Lucas County Board of Developmental Disabilities
Adult Changing Room Renovation
1155 Toledo, Ohio 43614
PMBA Project No. B322-6012
Thursday, January 30, 2025

Addendum A2

PMBA Architects
114 Louisiana Avenue
Perrysburg, Ohio 43551
(419) 873-8450

NEW FLOOR & REFLECTED CEILING PLANS & WALL TYPES

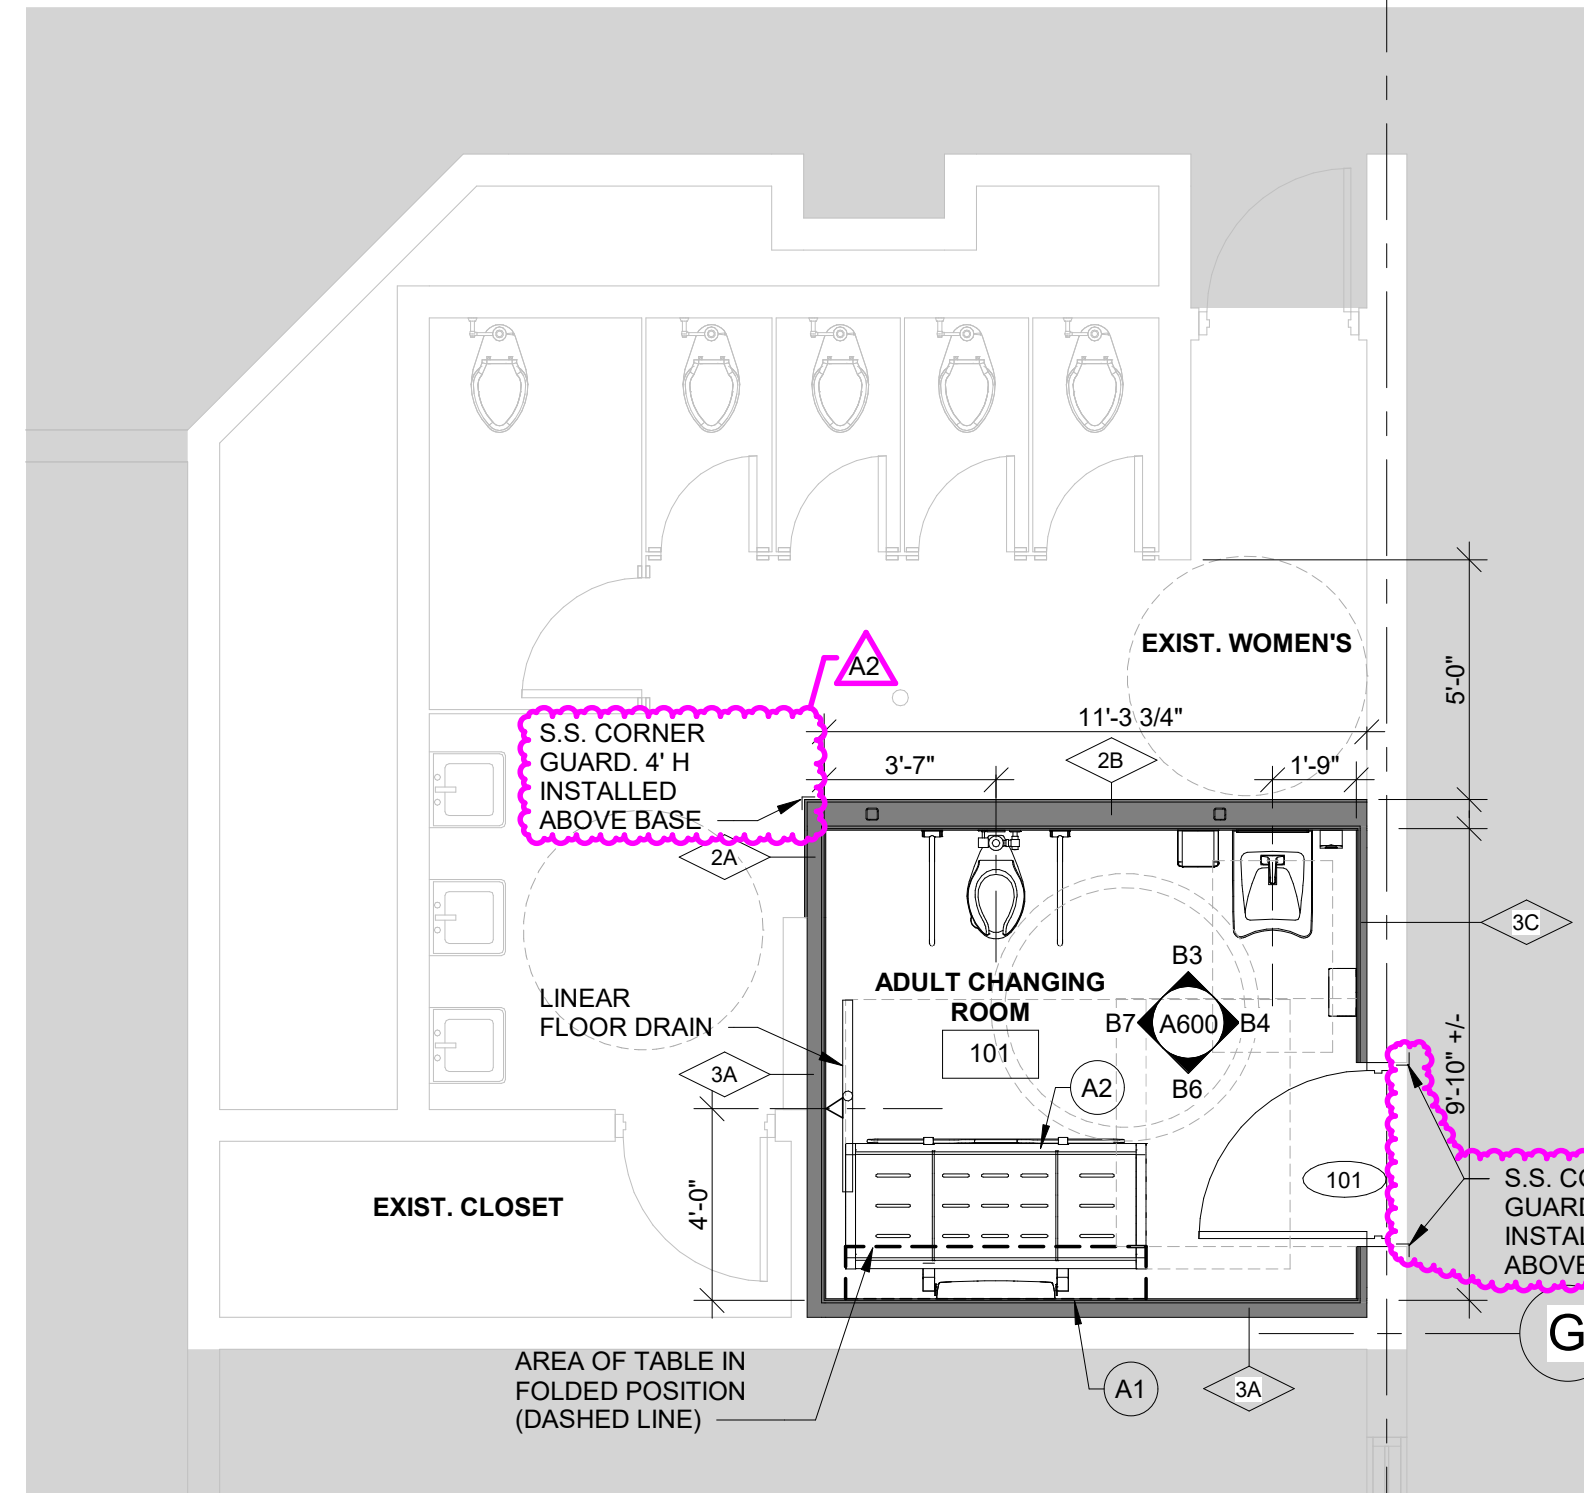
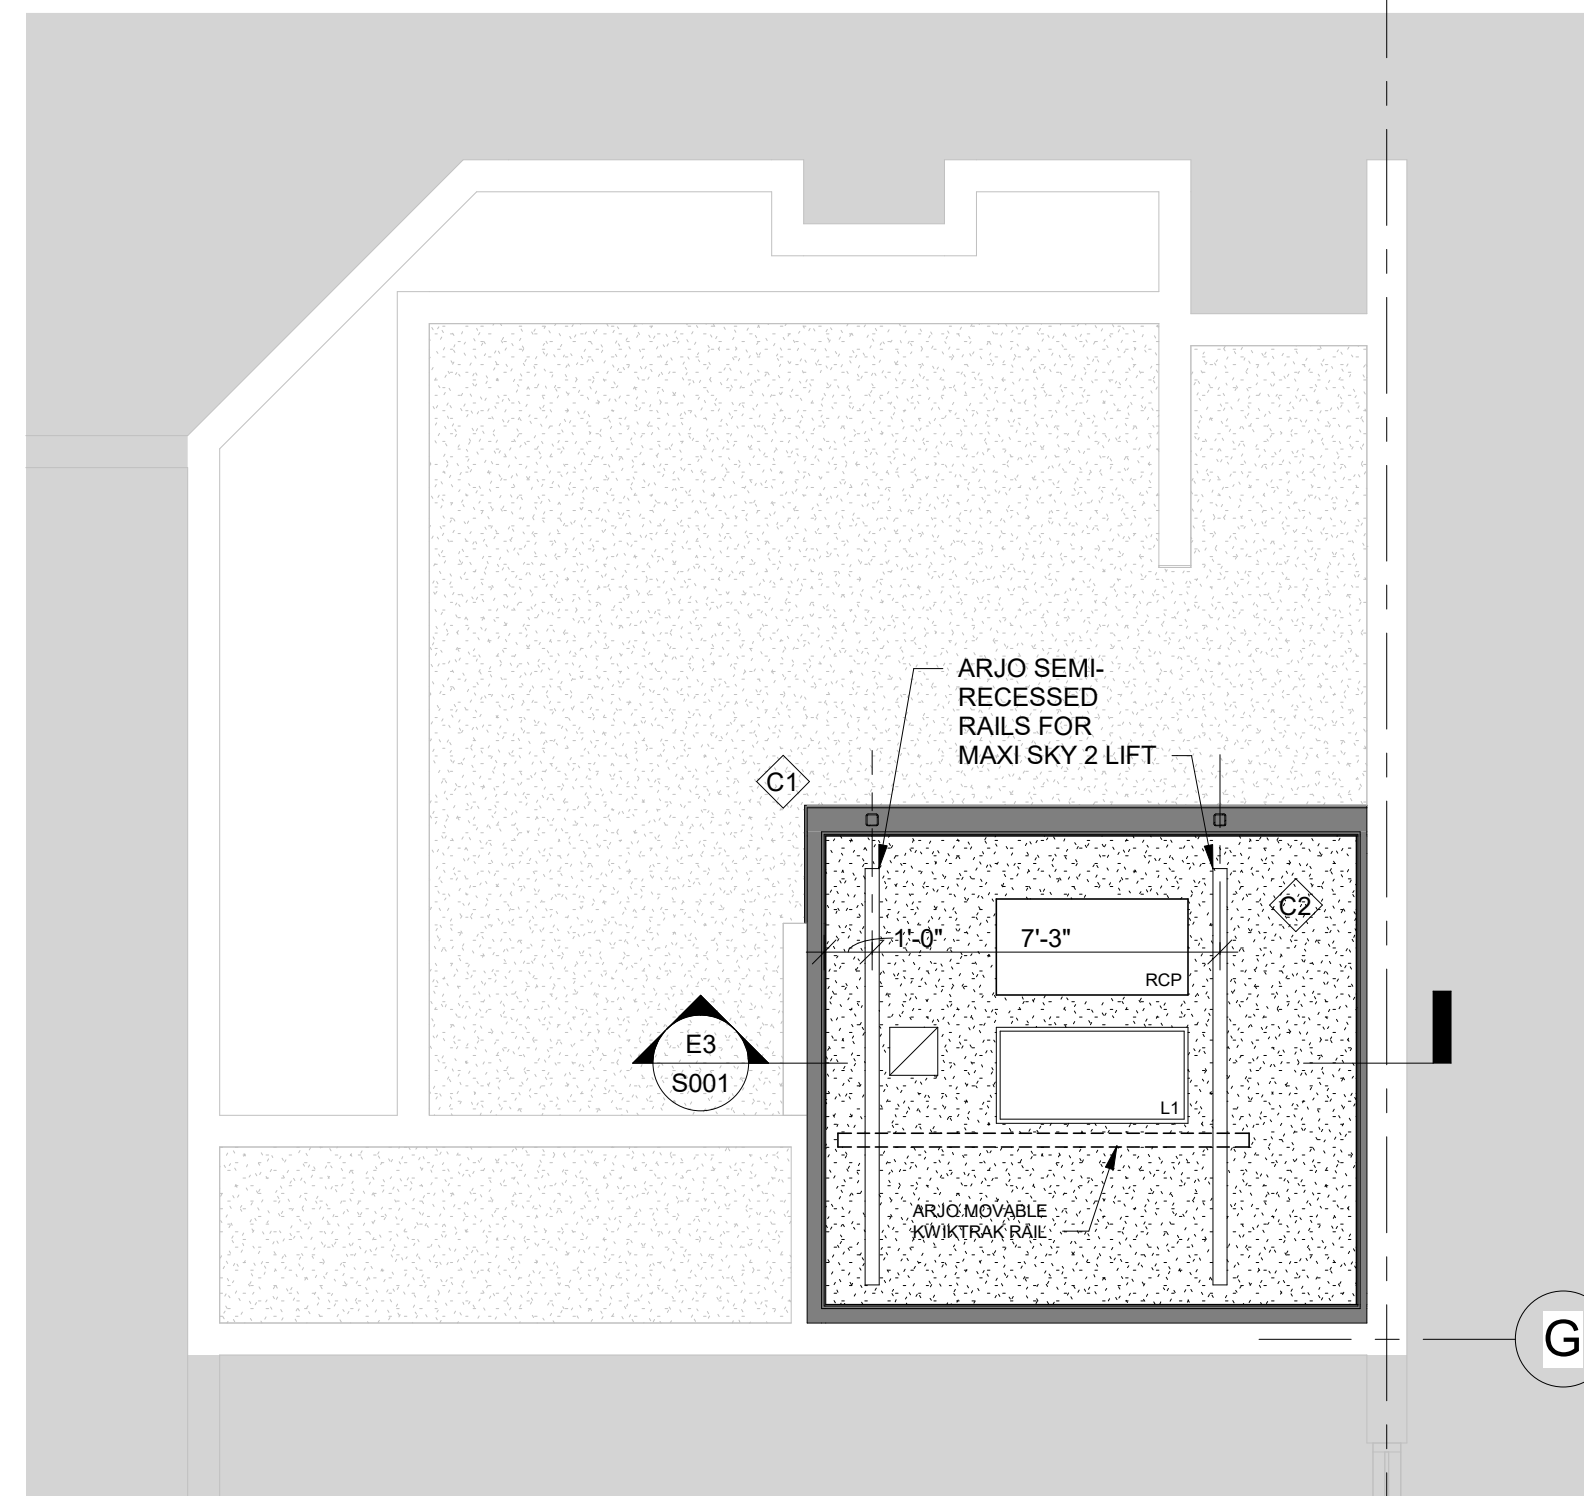
Item 1 Sheet A101, New Floor & Reflected Ceiling Plans & Wall Types (Drawing Reissued)

1.1 Added note addressing corner guard in Exist. Women's restroom.

1.2 Added corner guards and note at door 101.

DRAWING TITLE
ROOM FINISH, MATERIALS, AND DOOR SCHEDULES

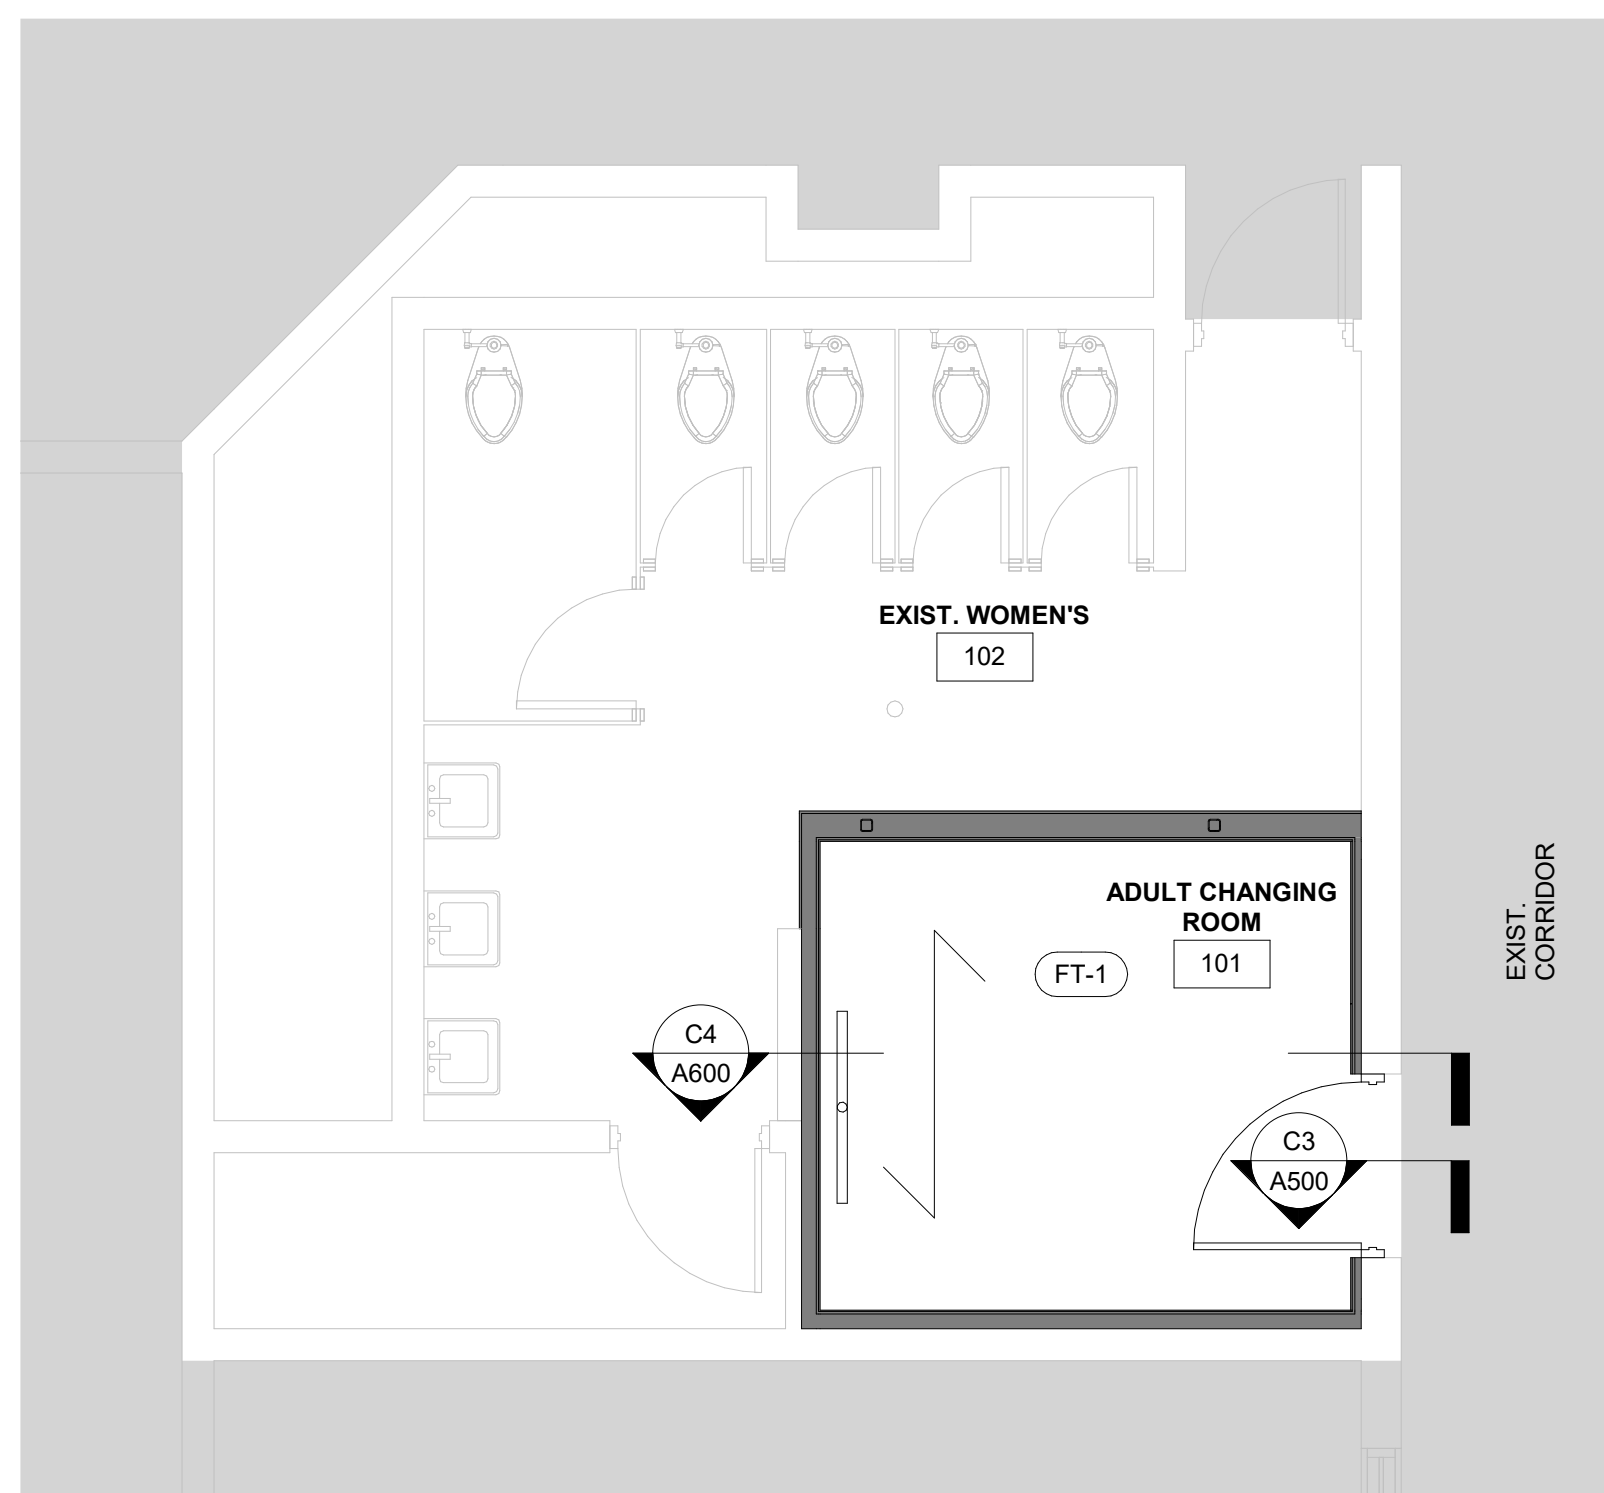
Item 2 Sheet A500, Room Finish, Materials, and Door Schedules (Drawing Reissued)

- 2.2.1 Added line-item EXISTING CORRIDOR to schedule.
The Contractor is expected to finish the corridor to match existing.
Paint the existing wall that new door is on from adjacent window jamb to end of wall at corridor north intersection.
- 2.3 Added Alternate No. 1 description for alternative wall tile selections.
- 2.4 Added note regarding restoring concrete subfloor where affected by new construction in existing Women's restroom. The floor in that restroom is to receive new LVT in the future.
- 2.5 Hardware Set
 - 2.5.1 Changed actuator type to a square push plate.
